MICE Spectrometer Solenoid

Muon Accelerator Program (MAP)

PMG Meeting

January 12, 2011

Proposed 5 + 1 Cryocooler Layout

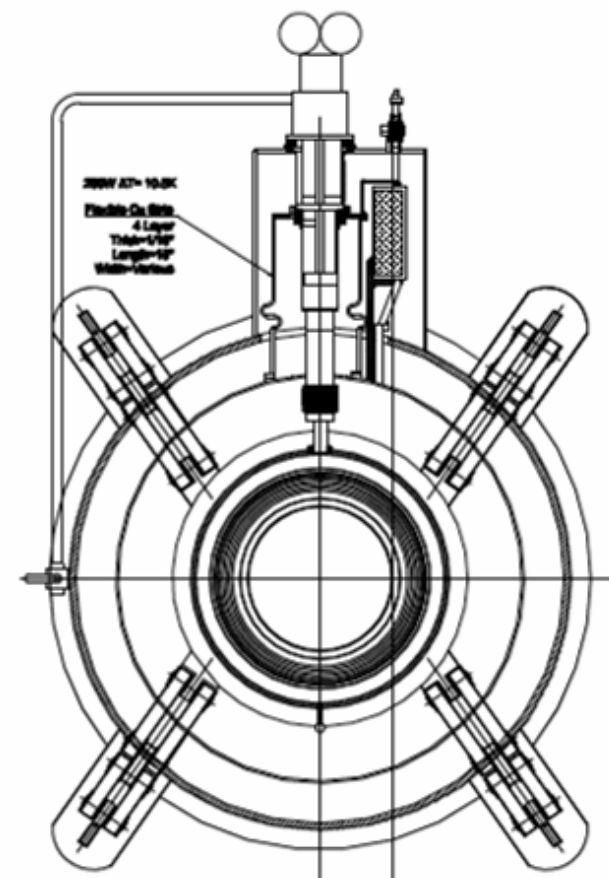
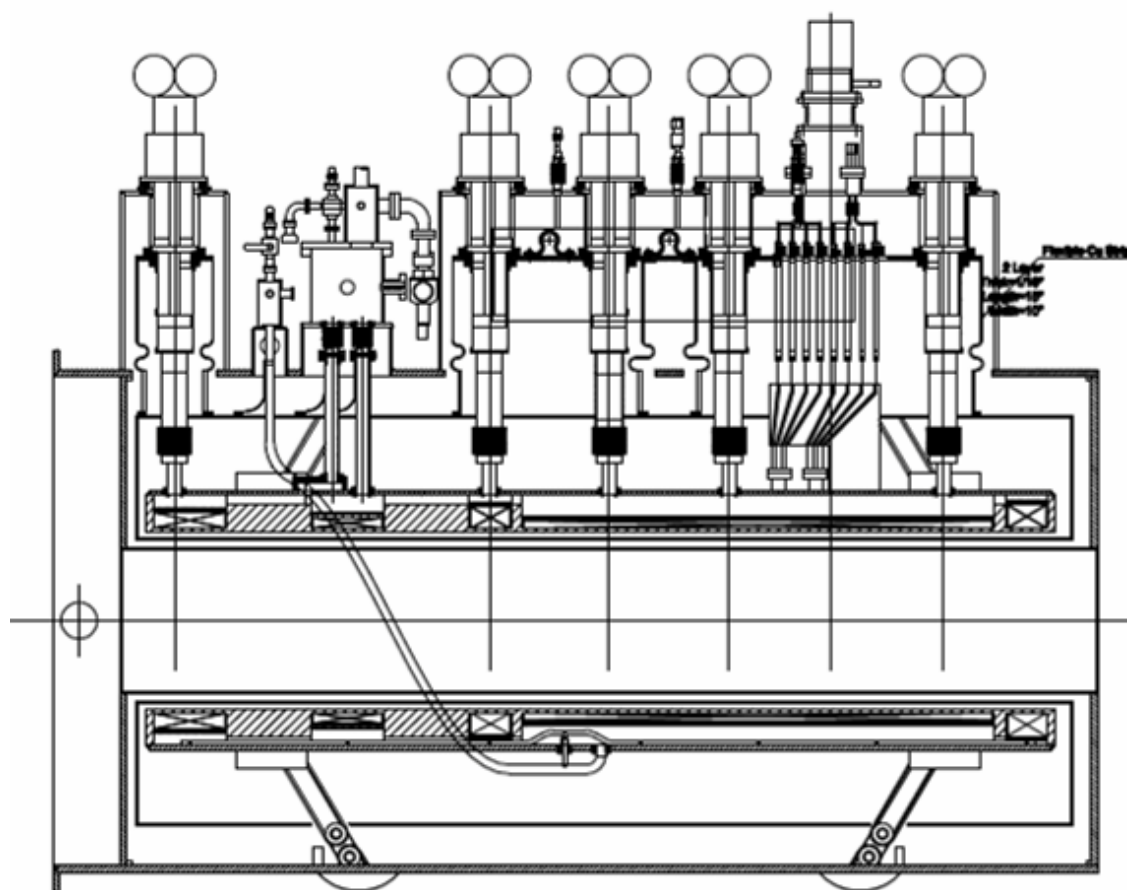
- A preliminary design modification plan has been developed by LBNL. The plan includes the following:
 - reduction of heat leaks to the cold mass
 - the addition of more cryo cooling power
 - assessment of the suitability of the passive quench protection system
 - modification of the LTS leads to prevent burn-out
- The plan has been detailed in a separate document and posted on the website for this meeting
